Groundwater Application Review Summary Form

Application # G- 19445

PUBLIC INTEREST REVIEW FOR GROUNDWATER APPLICATIONS

TO: Water Rights Section
 FROM: Groundwater Section Dennis Orlowski
 Date January 7, 2025
 SUBJECT: Application G- 19445 Supersedes review of _____
 Reviewer's Name
 Date of Review(s)

Cross-section of nearby CRBG wells only (PROP601 is proposed POA Well 2; three low-lying areas/valleys correspond to nearby sections through Sandy River)

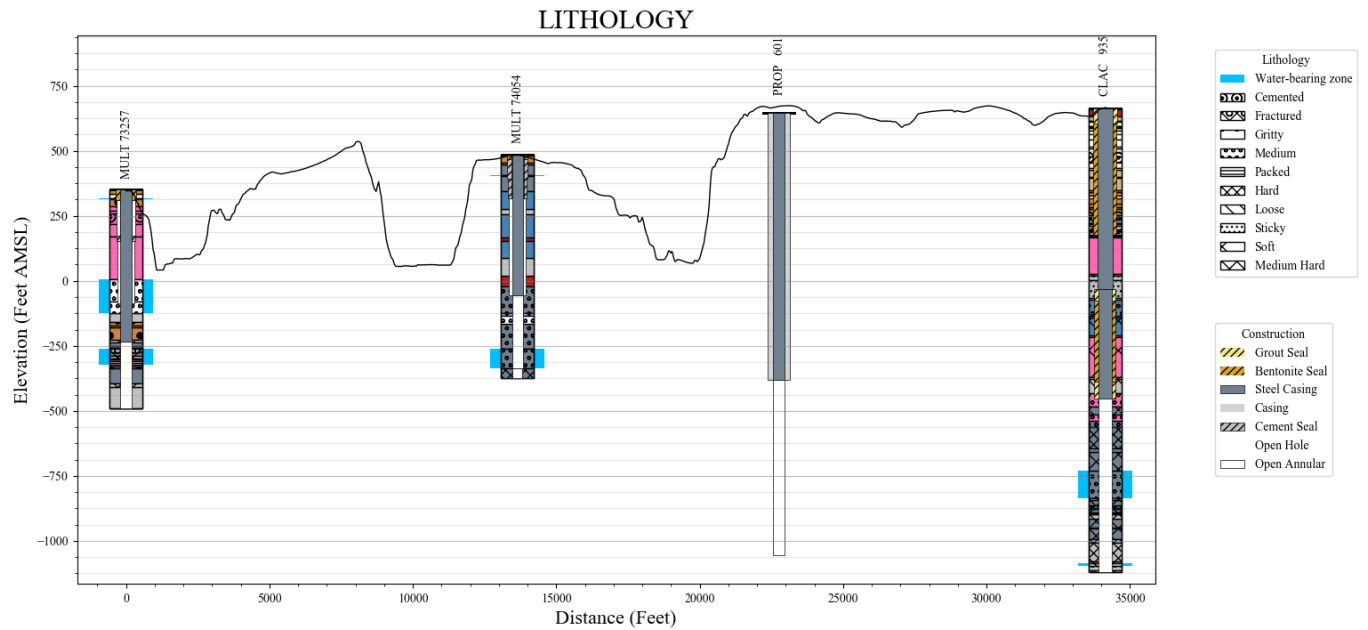
- B3. **Groundwater availability remarks:** Proposed POA Well 2 (“Sherwood Basalt W2”) will obtain groundwater from the CRBG aquifer system, which at this location is overlain by approximately 1000 feet of alluvial sediments (Swanson and others, 1993; McFarland and Morgan, 1996). Only three other CRBG wells are known to exist in this general area: MULT 74054 (~9100 feet northeast), MULT 73257 (~11,300 feet north-northwest), and CLAC 935 (~11,400 feet south). All three of these CRBG wells are authorized POA for irrigation or nursery uses.

The proposed construction for POA Well 2 (“Sherwood Basalt W2”) would be most similar to that of CLAC 935, specifically the cased-and-sealed portions and total depths. Furthermore, proposed POA Well 2 would be sealed below, or very near, the bottoms of both MULT 73257 and MULT 74054. Therefore, only CLAC 935 would likely be susceptible to injury due to the proposed use of POA Well 2. However, despite the relatively very deep static water levels (~560 ft bls) in CLAC 935, there remains over 1200 feet of available drawdown in that well (see attached hydrograph). CLAC 935 is also located about 2.2 miles south of the proposed POA Well 2 location. Consequently, it is unlikely that the proposed use of POA Well 2 will cause enough additional drawdown in CLAC 935 to prevent its authorized use.

Hydrograph - Water-Level Measurements in Nearby CRBG Wells

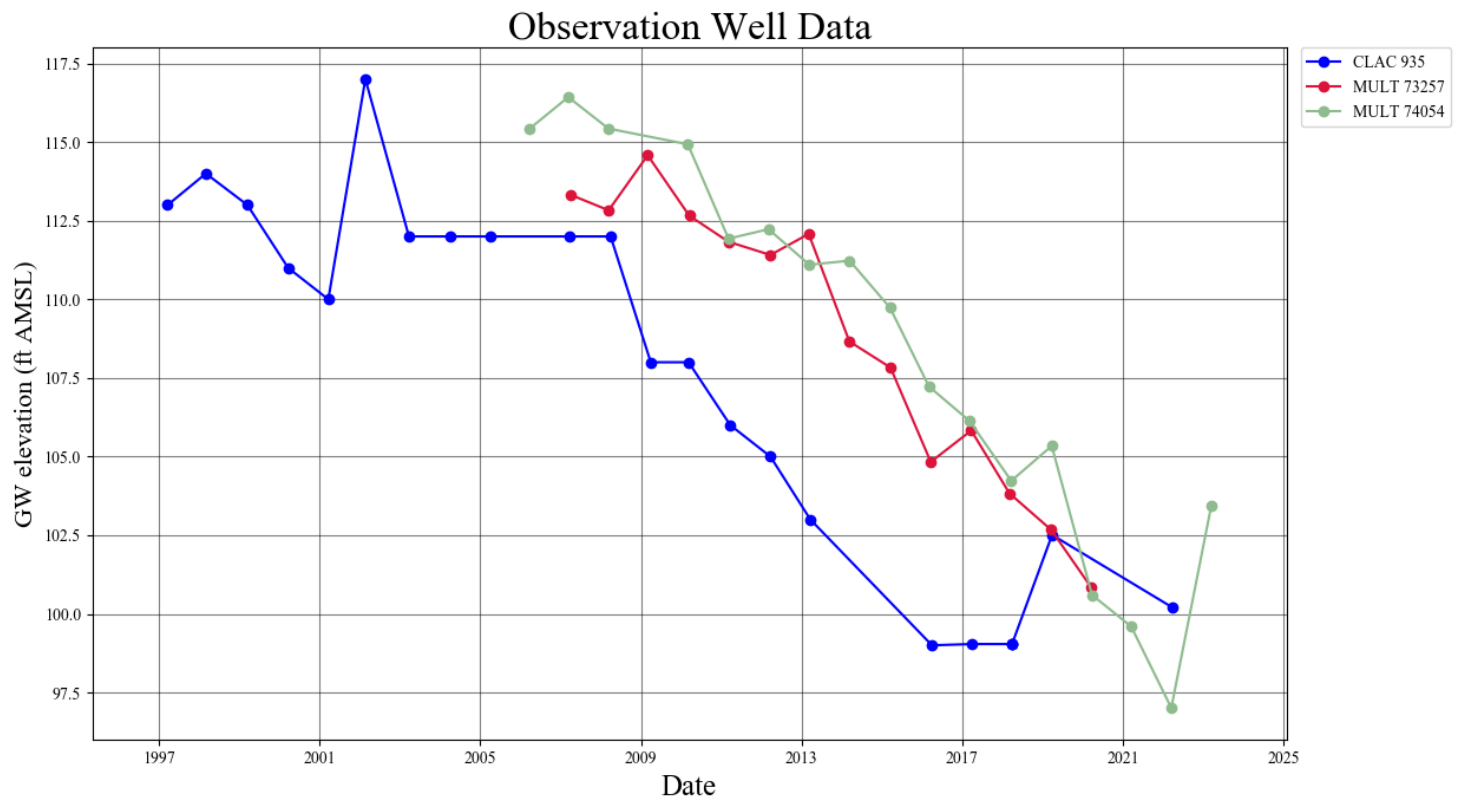
Historic static water levels in all three CRBG wells in the area have shown generally sustained declines, on the order of 15-20 feet over the past ~20-25 years (see attached hydrograph). These declines have occurred despite the relatively low use of this aquifer system, and suggests that recharge of the deep CRBG aquifer system in this area is not sufficient to meet even these very few groundwater uses. Also, special permit conditions for the Sandy Basin (OAR 690-503-0060) state that use of water from a well “shall be regulated if the well displays: (a) an average water level decline of three or more feet per year for five consecutive years; or (b) a total water level decline of fifteen or more feet.” Based on the water level trends observed in existing nearby CRBG wells, it is likely that this proposed use of POA Well 2 would trigger the Sandy Basin decline conditions within perhaps 15 years or less. **These factors suggest that the capacity of the local groundwater resource is not sufficient to support this proposed use.**
